Inland Transport Committee

World Forum for Harmonization of Vehicle Regulations

Proposal for Supplement 2 to the 02 series of amendments to UN Regulation No. 129 (Enhanced Child Restraint Systems)

Submitted by the Working Party on Passive Safety*

Figure 2

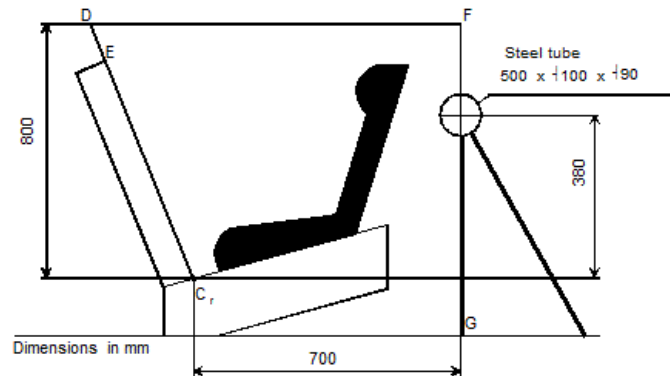
Paragraph 6.6.4.1.2.1, amend to read:

"6.6.4.1.2.1. Head excursion: no part of the head of the dummy shall pass beyond the planes FD, FG and DE, as shown in Figure 2 below. This shall be judged up to 300 ms or the moment that the dummy has come to a definitive standstill whatever occurs first.

Except when testing using Q6 dummy where:

The value in relation to the FD plane is 840 mm

Where a test is conducted with paragraph 6.6.4.1.6.2. or paragraph 6.6.4.1.8.2. above, only the second configuration test results without 100 mm diameter bar will be considered.

1. Head impact area
 - 1.1. Definition of backrest head impact area

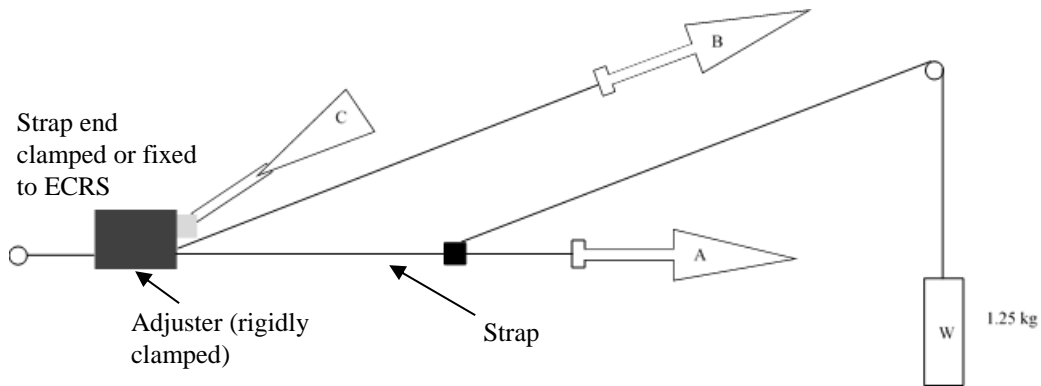
Annex 14, amend to read:

Method of defining head impact area of devices with backrests or impact shields and for rearward-facing devices defining the minimum size of side wings

Place the device on the test bench described in....
 - 1.2. Definition of impact shield head impact area

The impact shield head impact area is the whole upper surface of the impact shield, which comprises any surfaces visible from the top, looking down on the shield."

Figure 1.

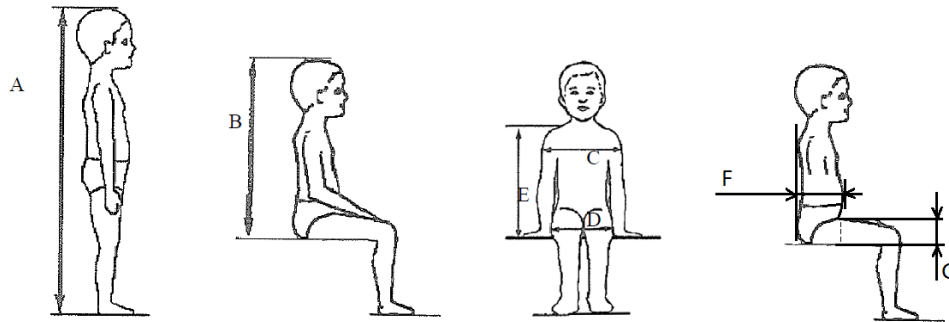
Annex 18, amend to read:

Geometrical dimensions of Enhanced Child Restraint Systems

Figure 2
ECRS Measurement Device - Side and Front View of the measuring device

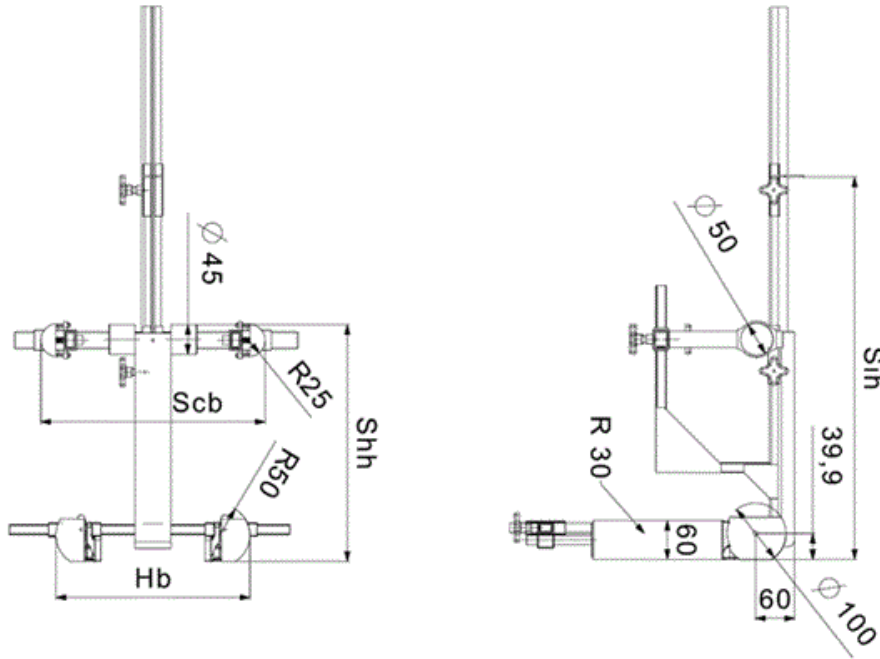
All lateral dimensions are measured under a contact force of 50 N with the devices described in Figure 2 and Figure 3 of this annex and the following tolerances will applied:

The mass of the devices described in Figure 2 and Figure 3 of this annex shall be 10 kg +/- 1 kg

For integral or non-integral ECRS the device shown in Annex 18, Figure 2 shall be used.

Figure 3
Side and Front View of the measuring device for measurements applicable to Enhanced Child Restraint Systems that feature an impact shield

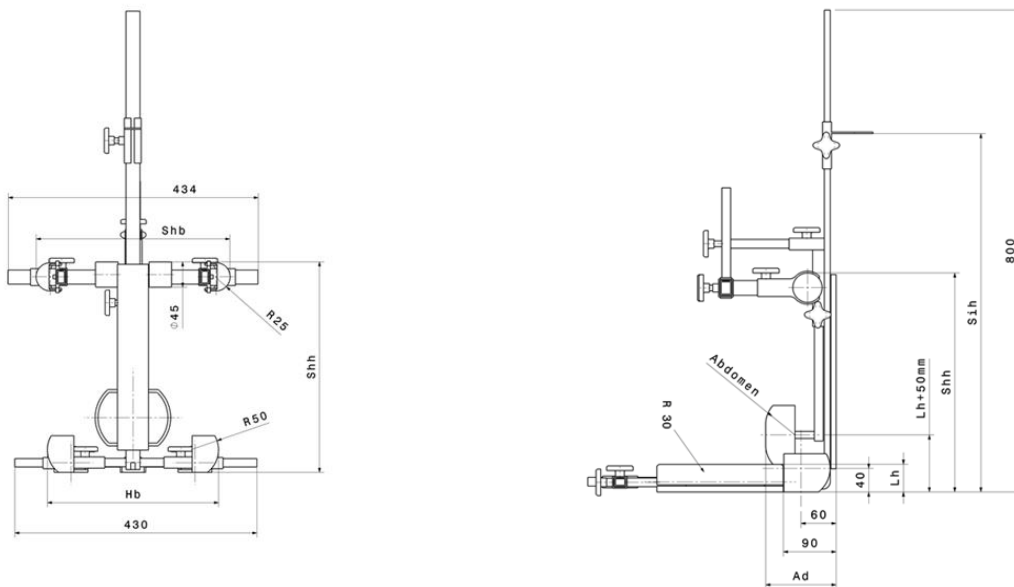
For ECRS with an impact shield the device shown in Annex 18, Figure 3 shall be used.
